**Document Title:** Decreasing The Response Time of the Model 405 Input Filter  
(AN 41D)

**Part Number:** 5989-6246EN

## APPLICATION NOTE 41D

### DECREASING THE RESPONSE TIME OF THE MODEL 405 INPUT FILTER

Figure 2.

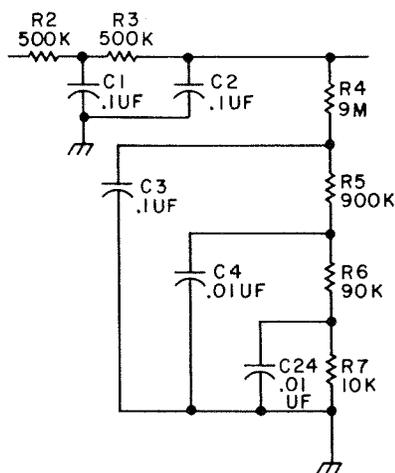
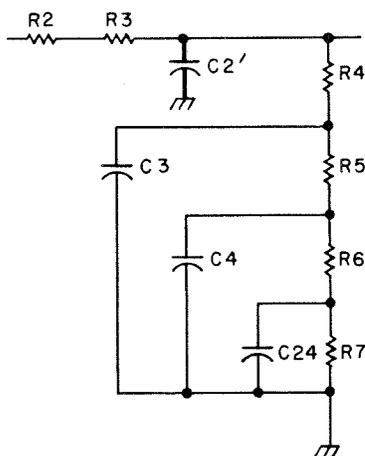
Modification 1 - To reduce the response time on the  $\pm .999$  volt range, remove C1 and replace C2 with a  $0.01 \mu\text{f}$ , 1000 vdcw polystyrene capacitor. For convenience, two  $0.02 \mu\text{f}$  600 vdcw capacitors may be used in series.

Input Filter Modified for Fast Response on  $\pm .999$  V Ranges

Figure 3.

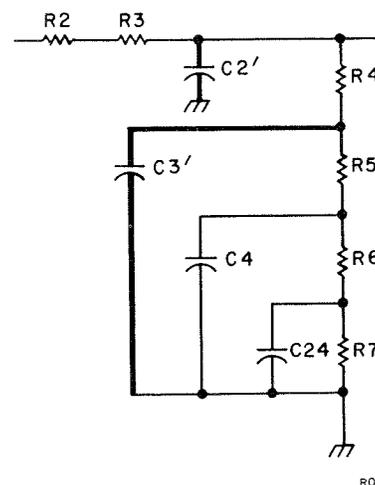
Modification 2 - To reduce the response time on all ranges, perform Modification 1 and in addition remove C3 and replace with a  $0.01 \mu\text{f}$ , 600 vdcw polystyrene or mylar dielectric capacitor.

Input Filter Modified for Fast Response on all Ranges
